STS-115/12A

FD 04 Execute Package

MSG	Page(s)	Title
036	1 - 2	FD04 Summary Timeline (pdf)
034	3 - 13	FD04 Flight Plan Revision (pdf)
035	14 - 15	FD04 Mission Summary (pdf)
027	16 - 18	Contingency P3/4 Installation with Failed SSAS RTL (pdf)
028	19 - 20	Contingency RTL Loss After WR Limping (pdf)
032	21 - 23	1.301 AVU SPEE CAM P3 Truss Install (pdf)
037	24 - 25	Loose SARJ Thermal Blanket Troubleshooting (pdf)
038	26	FD04 Water Activity Summary (pdf)
039	27 - 30	P3 Activation Procedure Updates (pdf)
040	31	FD04 Monitor Ops (pdf)
041	32	FD4 Lighting Predicts for AVU Operations (pdf)
042	33	Robotics Procedure Update Rationale for FD04 (pdf)
043	34 - 35	BPSMU Audio Config (pdf)
044	---	FD03 MMT Summary (pdf - Electronic Only)

MLI FLAP LOOSE

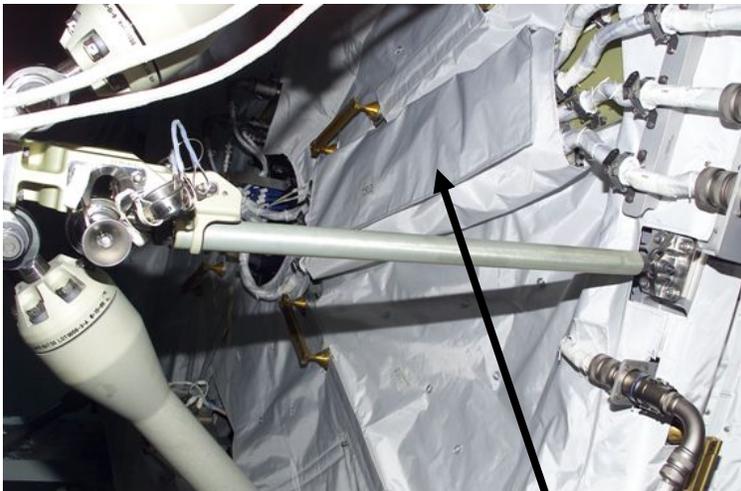
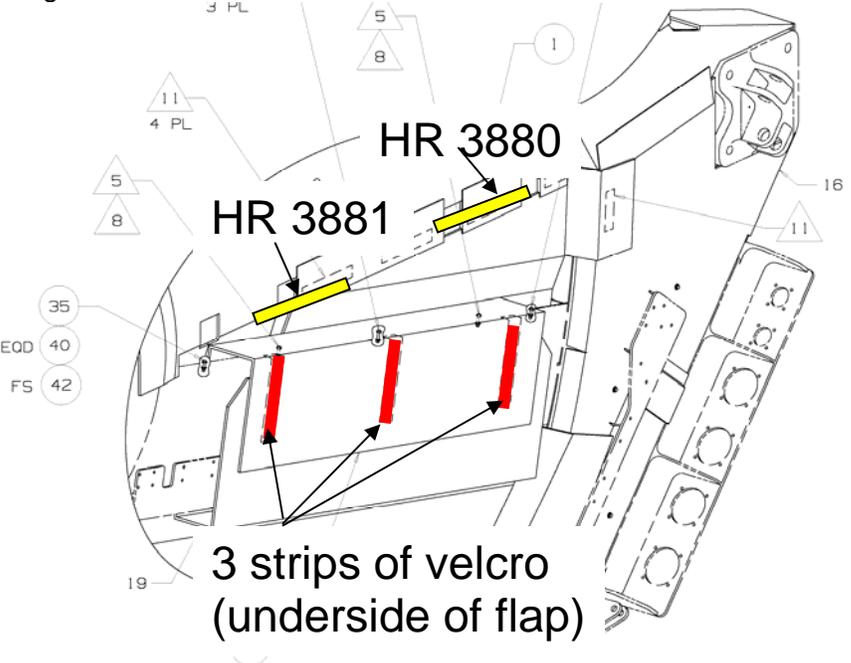
- During review of Flight Day 2 video, a thermal blanket on the P3 outboard bulkhead was observed to be loose. Review of payload bay walkdown photography revealed that this happened on the ground due to 1-G effects and the blanket was reattached.
- We will plan for you to reattach the thermal blanket during EVA 2 during SARJ Prep Tasks.
- Your best access to the protruding thermal blanket will be from face 1; this will avoid interference from struts and power cabling. Once inside the worksite, reattach the opened thermal blanket to the attached thermal blanket. There are three 1.5" wide Velcro strips on the open flap that must be mated to corresponding Velcro flaps on the attached thermal blanket. See the third photo below

Figure 3: Starboard OMS Pod Protruding Blanket

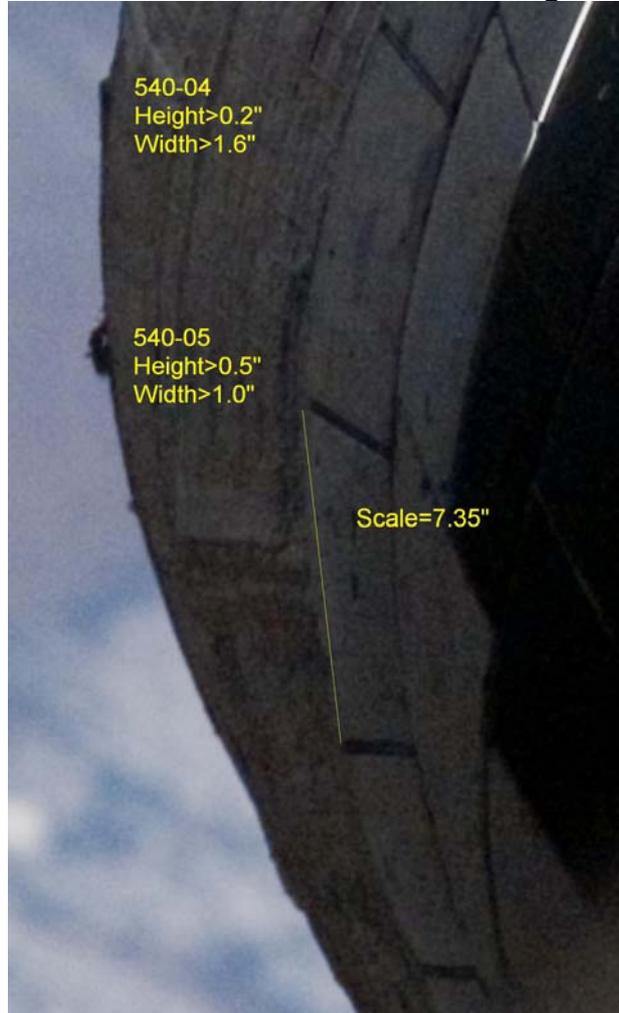
1 Based on all of the inspection data to date there are only two items of interest
2 remaining. These items are the protruding gap filler on the left hand ET door (See
3 Figure 2) and the thermal blanket protrusion of the right hand OMS pod (See Figure
4 3). The overall plan is to collect additional non-OBSS based imagery data using
5 ISS, RMS, or SSRMS assets. More details on this plan will be provided as it
6 develops over the next 24 hours.

8 Additionally, thermal and structural analysis largely based on the conservative Mach
9 25 boundary layer trip work from STS-121 is underway in an attempt to clear the ET
10 door gap filler. A debris liberation and transport analysis for this gap filler will also be
11 performed. More details from this analysis will be provided as they become
12 available.
